SUBDIVISION REVIEW SHEET**CASE NO.:** C8-2018-0043.2A**COMMISSION DATE:** May 4, 2021**SUBDIVISION NAME:** Parkside Section 1 at Wildhorse Ranch**ADDRESS:** 9936-1/2 Lindell Lane**APPLICANT:** Forestar Group**AGENT:** BGE, Inc. (Pablo Martinez)**ZONING:** PUD**NEIGHBORHOOD PLAN:** N/A**AREA:** 37.39 acres**LOTS:** 145**COUNTY:** Travis**DISTRICT:** 1**WATERSHED:** Decker and Gilleland Creeks**JURISDICTION:** Full Purpose**SIDEWALKS:** Sidewalks will be constructed along the subdivision side of Lindell Lane and along both sides of all proposed, internal streets.**VARIANCES:** None**DEPARTMENT COMMENTS:**

CITY OF AUSTIN –DEVELOPMENT SERVICES DEPARTMENT
SUBDIVISION APPLICATION – MASTER COMMENT REPORT

CASE NUMBER: C8-2018-0043.2A
UPDATE: U1
CASE MANAGER: Jennifer Bennett-Reumuth PHONE #: 512-974-9002

PROJECT NAME: Parkside Sec 1 at Wildhorse Ranch
LOCATION: 9936-1/2 LINDELL LN

FINAL PLAT
**PARKSIDE SECTION 1
AT WILDHORSE RANCH**

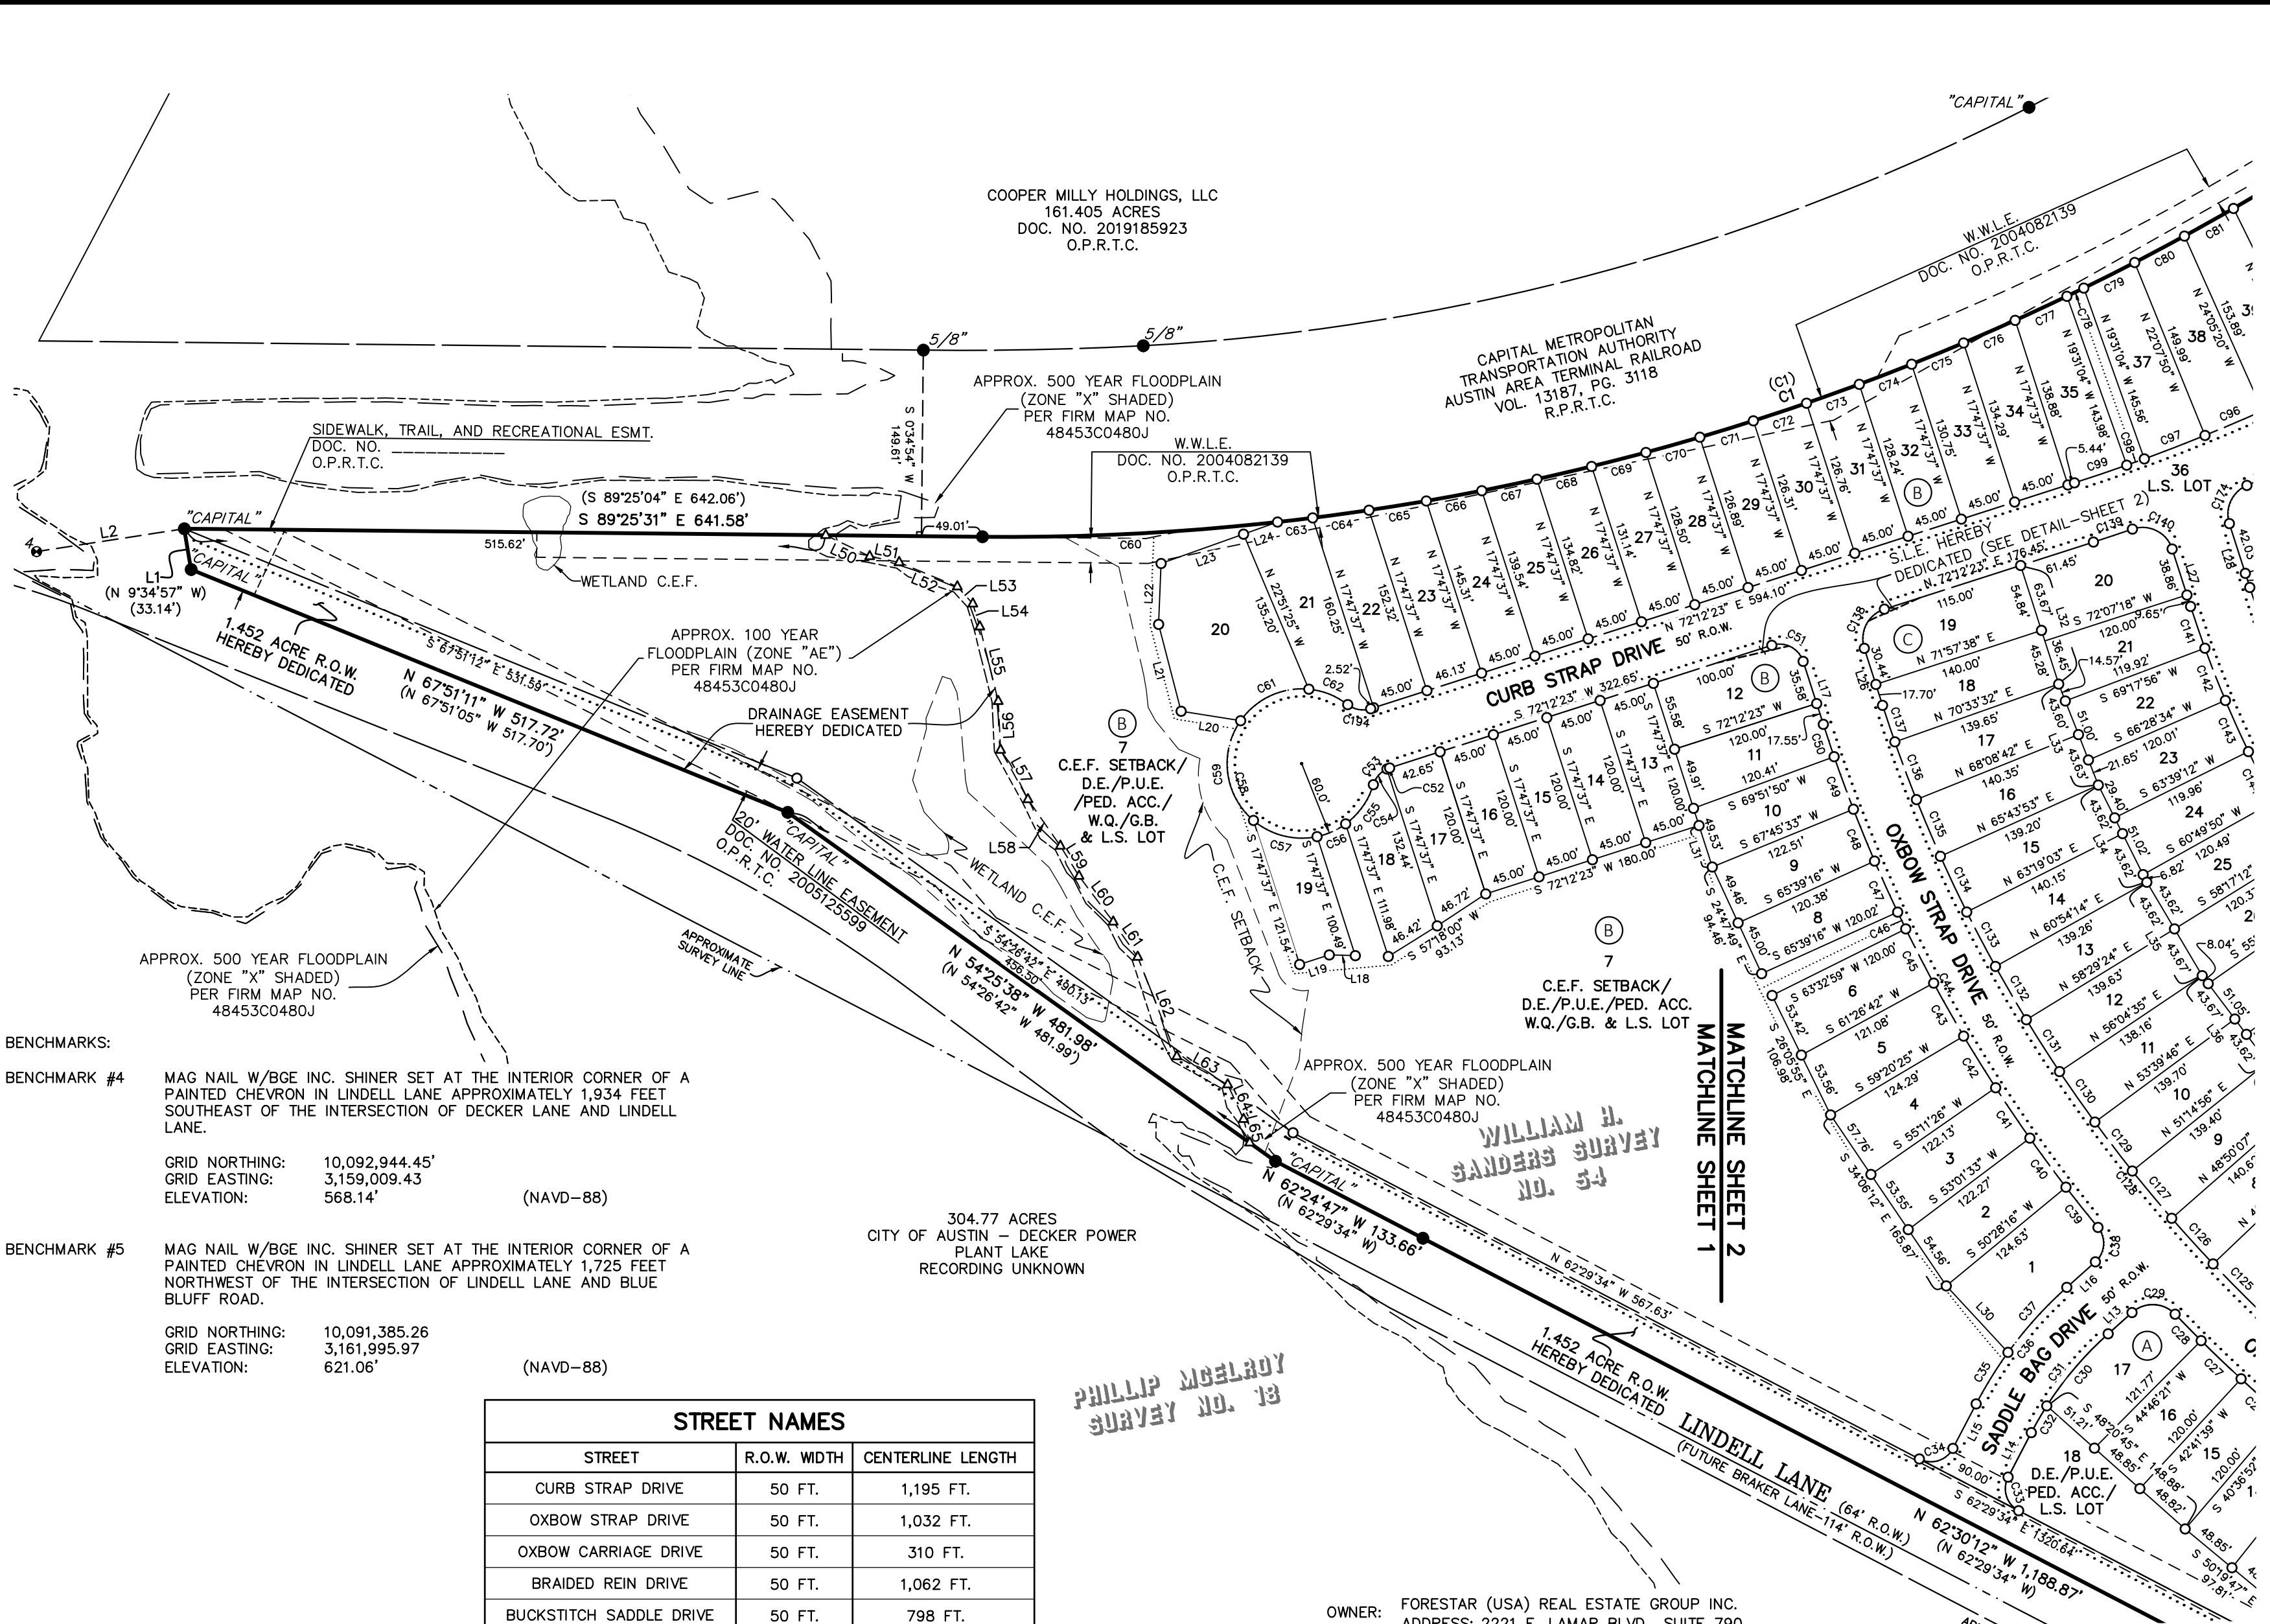
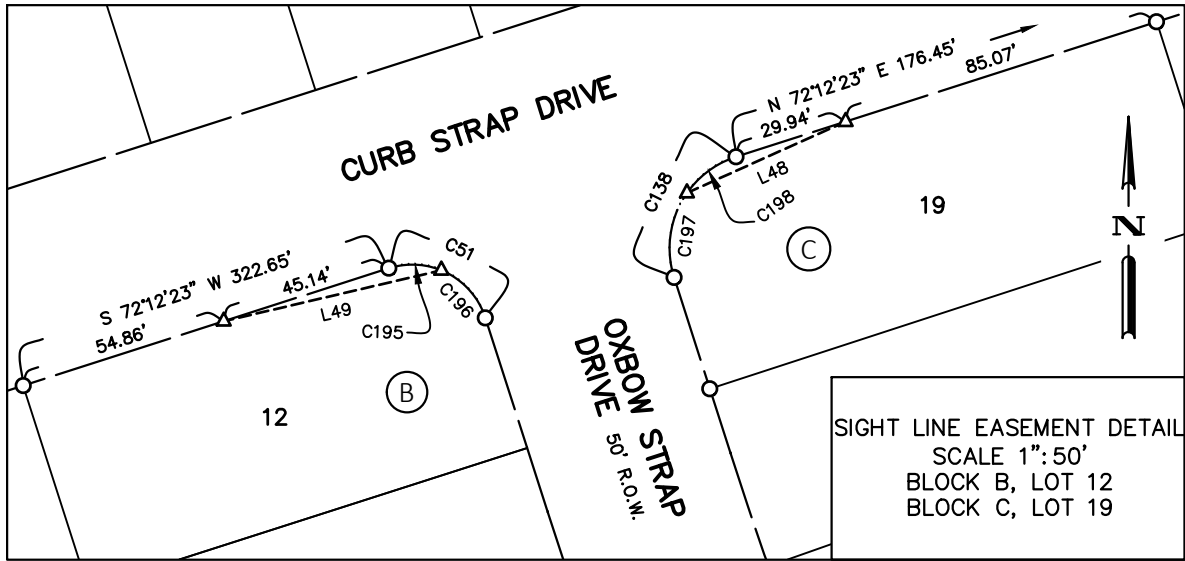
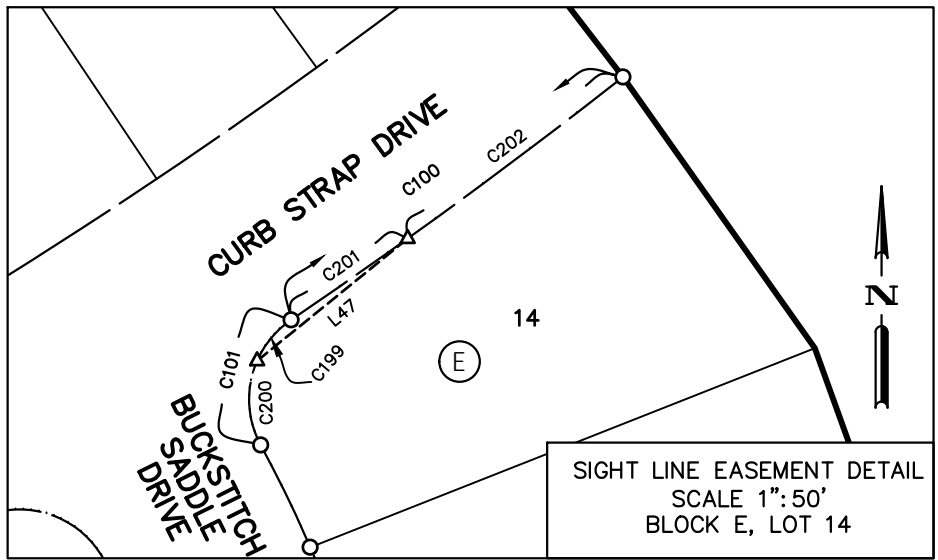
DE2: Engineer's seal, signature and date required [LDC 25-7-62].

DE3: Add the following Floodplain Note [LDC 25-7-152]:

"The 100 year floodplain is contained within the drainage easement(s) shown hereon. (No or A) portion of this tract is within the boundaries of the 100 year flood plain of any waterway that is within the limits of study of the Federal Flood Insurance Administration FIRM panel # _____, dated _____ for _____ (name of city of county)."

This must be certified by registered professional engineer.

SR 7. The "Sidewalk, Trail, and Recreational Easement" that is to be dedicated by separate instrument should be recorded in advance of the plat or concurrently with the plat. Please coordinate with the appropriate reviewer to have this document reviewed by Legal staff. 25-1-83

TR1. The Urban Trails Master Plan recommends a trail easement near Lindell Lane. The trail easement survey included with submittal is acceptable. At your earliest possible convenience, please send the accompanying legal documents to reviewer (adam.fiss@austintexas.gov) to be sent to law department for review. Document can be recorded in tandem with the plat.

U1: Required on the plat document.

U1: See DE2

U1: Pending

U1: Comment remains. Pending legal.
